Case Number/Name:	GDP22-002 & LR22-008 Copperleaf East GDP and Comprehensive Plan Amendment
Planner:	Kat Hammer – <a href="mailto:khammer@arapahoegov.com">khammer@arapahoegov.com</a> Gretchen Ricehill – <a href="mailto:gricehill@arapahoegov.com">gricehill@arapahoegov.com</a>
Engineer:	Emily Gonzalez - <a href="mailto:egonzalez@arapahoegov.com">egonzalez@arapahoegov.com</a>
Date sent:	December 27, 2022
Date to be returned:	January 24, 2023

**Subject: Copperleaf East General Development Plan and Comprehensive Plan (GDP22-002 and LR22-008); Arapahoe County, CO; CGS Unique No. AR-23-0011**

Thank you for your referral request to the Southeast Metro Stormwater Authority (SEMSWA) regarding the proposed Copperleaf East - GDP project. SEMSWA appreciates the opportunity to review the General Development Plan, Phase I Drainage Report and Comprehensive Plan Amendment and offers the following comments:

**PHASE I DRAINAGE REPORT**  
**Copperleaf East/Parcel O**

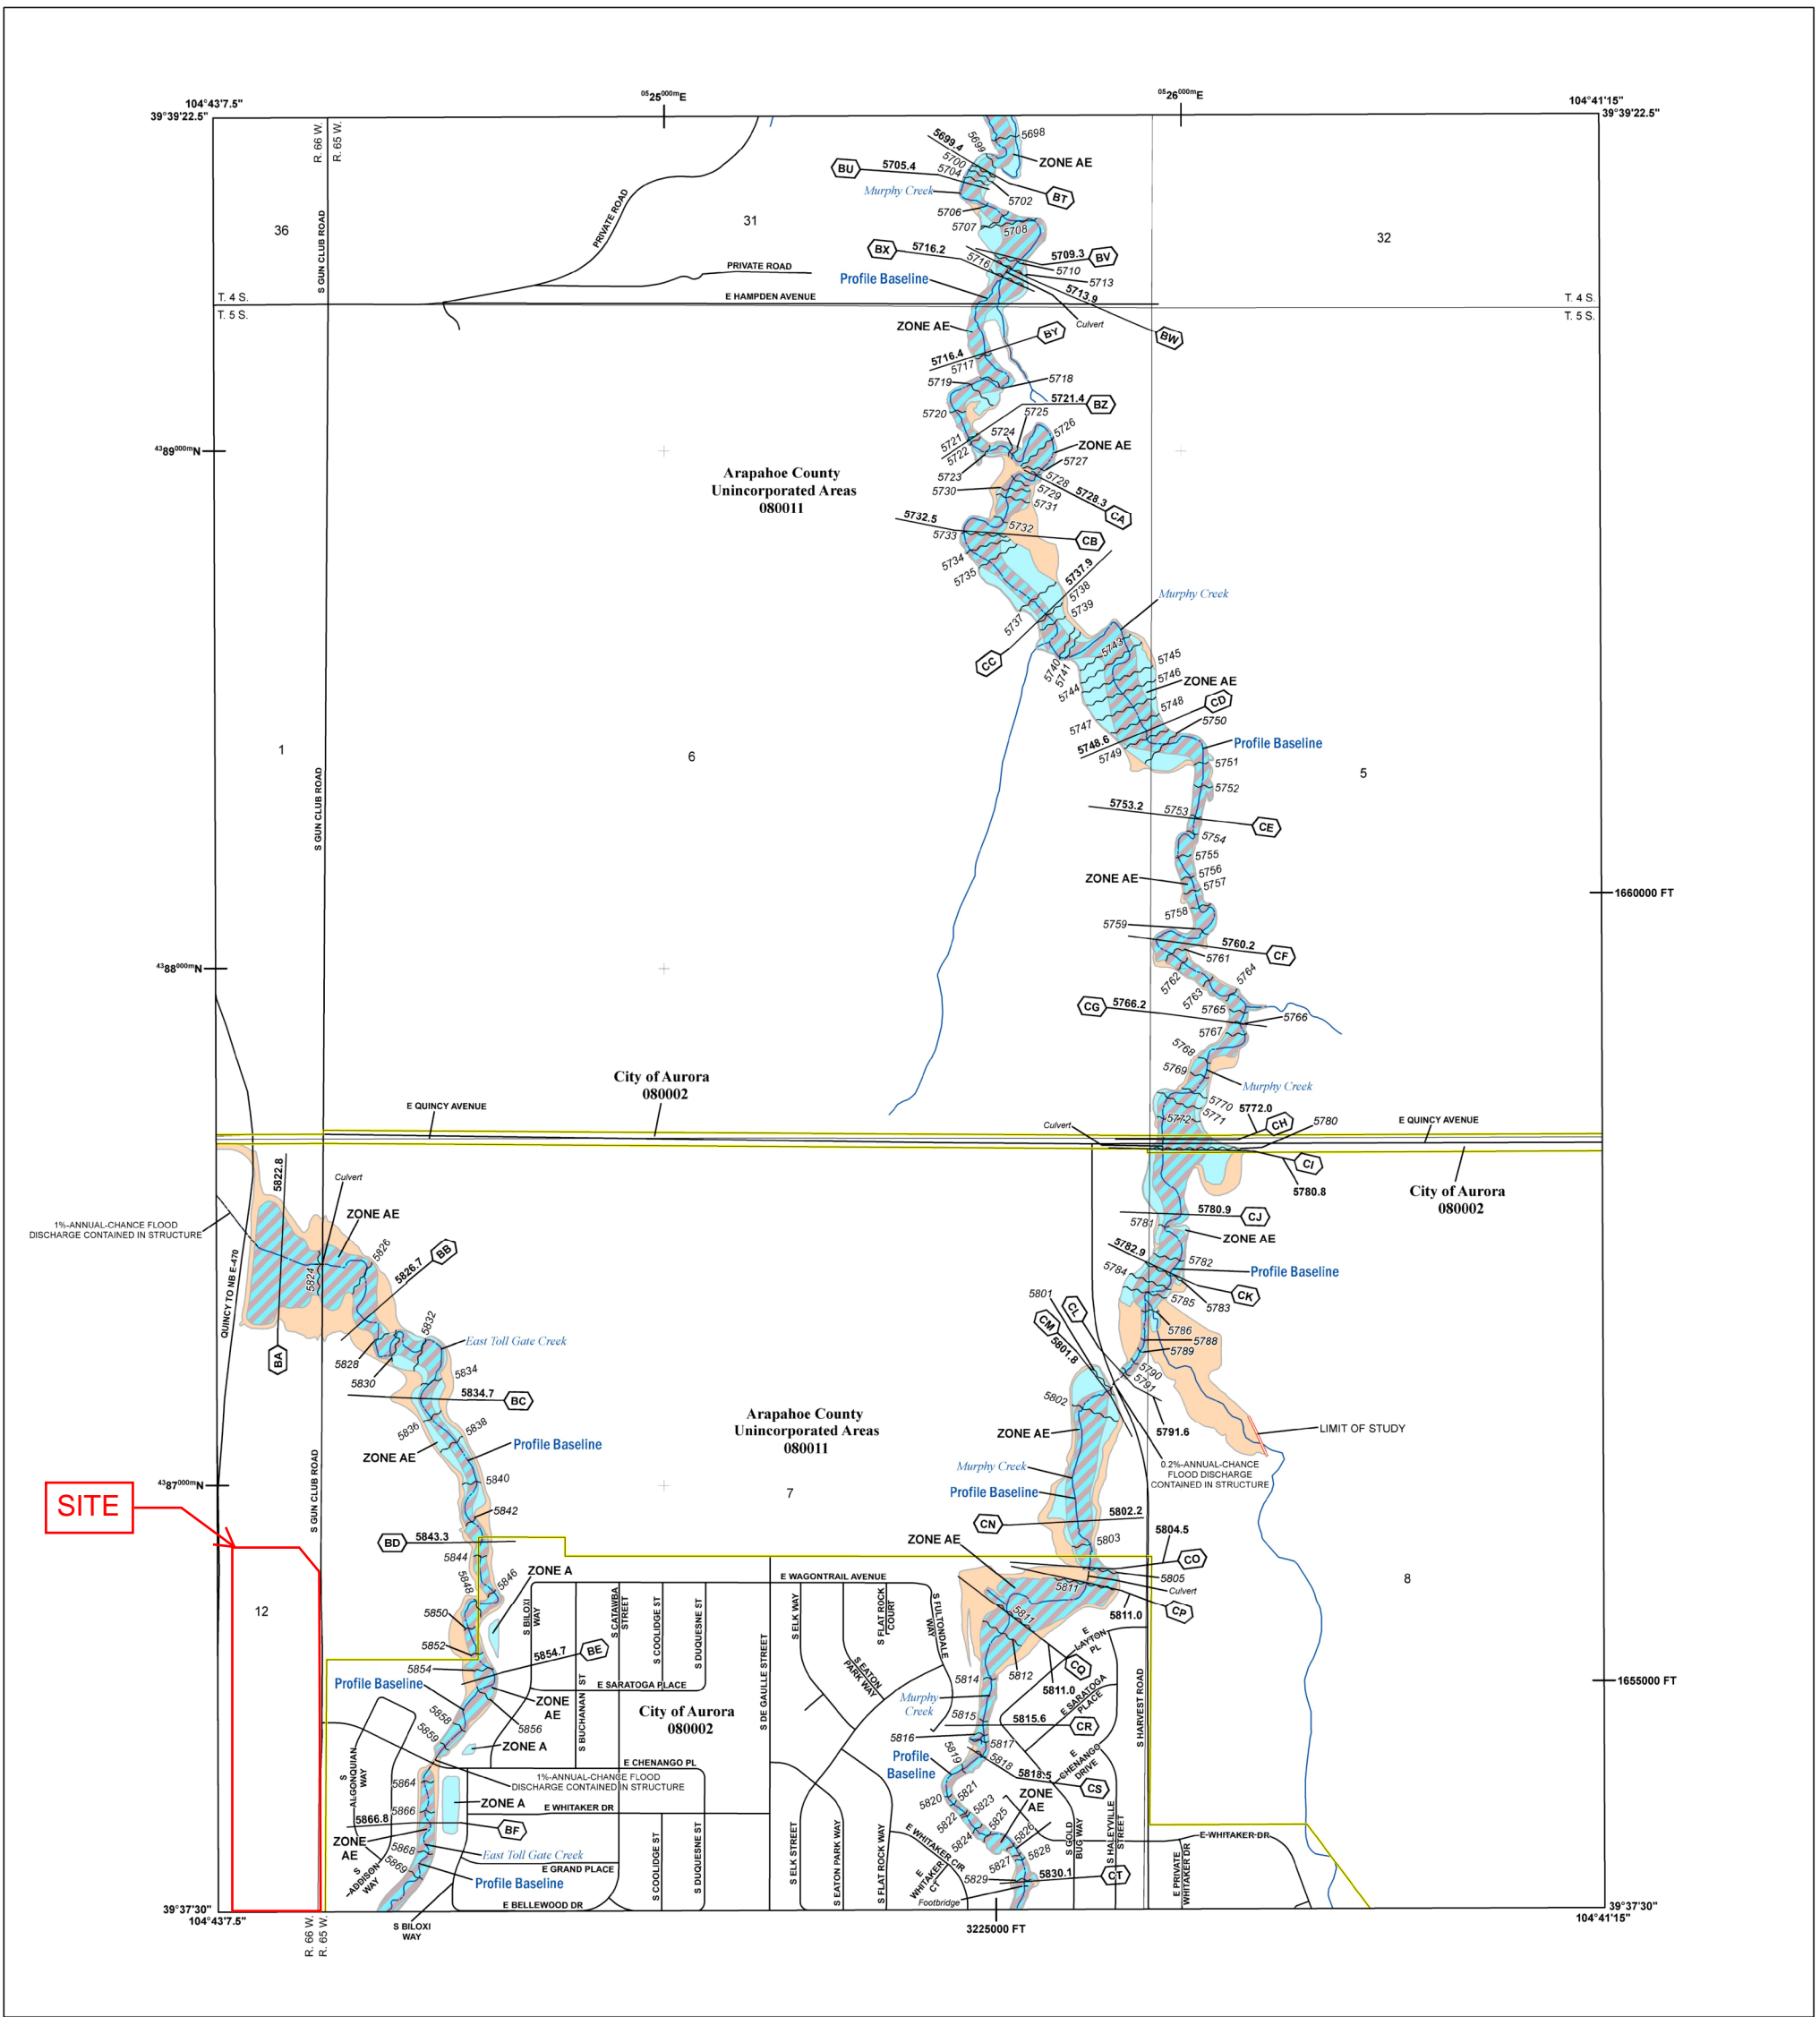
All pavement is to be considered 100% impervious. Please revise accordingly.
